**GULF STATES UTILITIES COMPANY**

River Bend Station - Unit 1  
Docket No. 50-458

Enclosed for your review is a Gulf States Utilities' response to the NRC Staff's concerns identified in Mr. A. Schwencer's letter of April 9, 1985. Please advise if further information is required.

## ATTACHMENT 1

Standby Cooling Tower

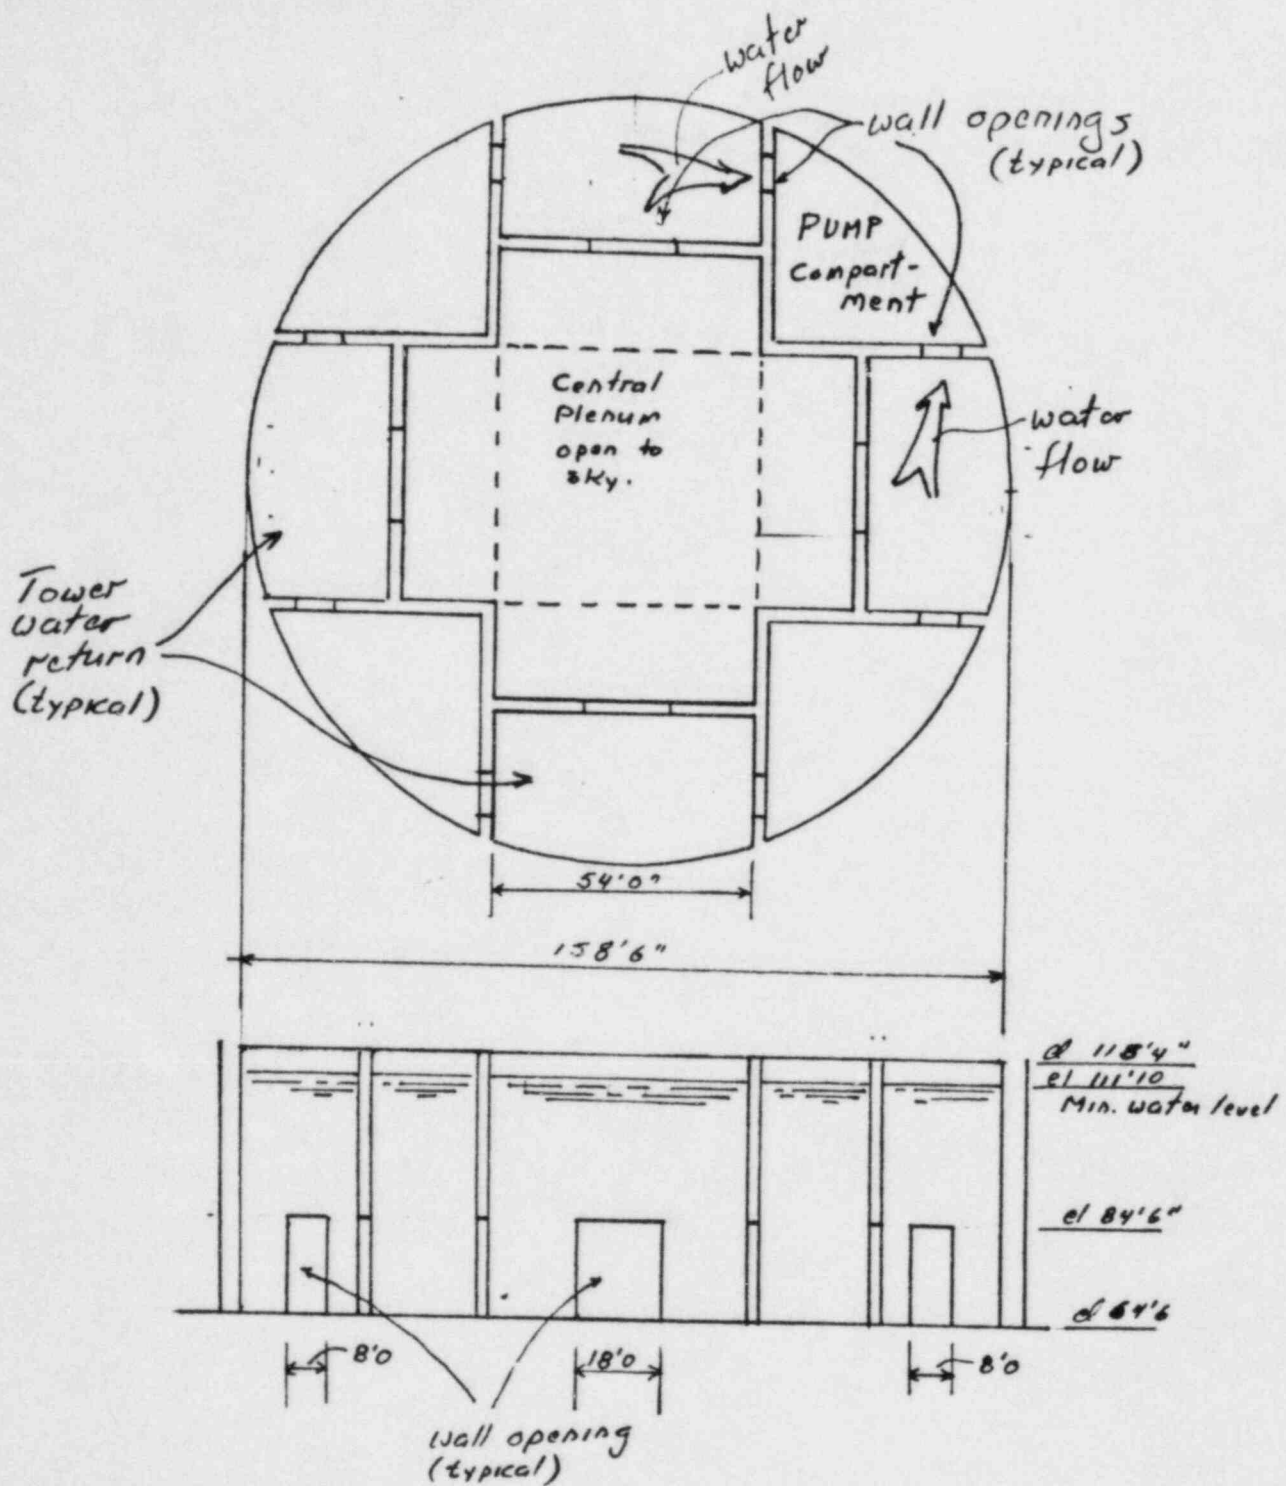
FSAR Section 9.2.5 discusses the temperature rise of the water in the ultimate heat sink based on using the cooling tower fans. The February 6th submittal identifies manual initiation of the fans two hours after the initiation of the design basis accident/event. The applicant should provide the results of an analysis of the ultimate heat sink water temperature assuming the maximum Tech. Spec. allowable basin water temperature, the most severe atmospheric conditions of 110°F and 100% RH (FSAR Section 2.3.2.2.1) and short circuiting of the cooling water with the fans not started for two hours and for not being started for three hours. As an alternative, the applicant may determine the maximum delay time for starting the fans which will not result in exceeding the maximum acceptable water temperature. This maximum delay time should include a sensitivity analysis of the time assumed for operator initiation of the fans.

With regard to short-circuiting, the standby cooling tower (SCT) water storage basin is a cylindrical concrete structure with a minimum water depth of 46'10" based on a el. 111'10" minimum water level. Structural walls supporting the SCT divide the basin into nine separate compartments which allow water flow through wall openings below elevation 84'6".

During the summer months, the water, partially shaded by the tower roof, will not exceed 82°F near the surface. Additionally water near the basin bottom will tend to cooldown to the 68°F ground water temperature. This condition of warm water with the atmosphere as heat source at the surface and cooler, denser water with ground water as heat sink toward the bottom will prohibit formation of convective currents leaving conduction as the dominant heat transfer mechanism.

During emergency tower operation, cool water is taken from the bottom of the pump compartment and returned via spray headers in the tower. If

the tower fans are not operating, the warm return water falls vertically through the fill and rains down upon the water in the return compartments. Because this water is warmer, hence less dense than the cooler water at the bottom, convective currents still cannot occur.

Water from the rest of the basin flows into the pump compartment through two 160 ft<sup>2</sup> openings. With 2 pumps in service flow velocities through these openings will be 0.1 ft/sec., far too slow to cause any turbulent mixing to occur in the basin.

In conclusion, even during tower emergency operation the water will remain essentially stagnant and the water near the bottom will not warm significantly until one complete turnover of the basin volume occurs around 7 hours after pump start.
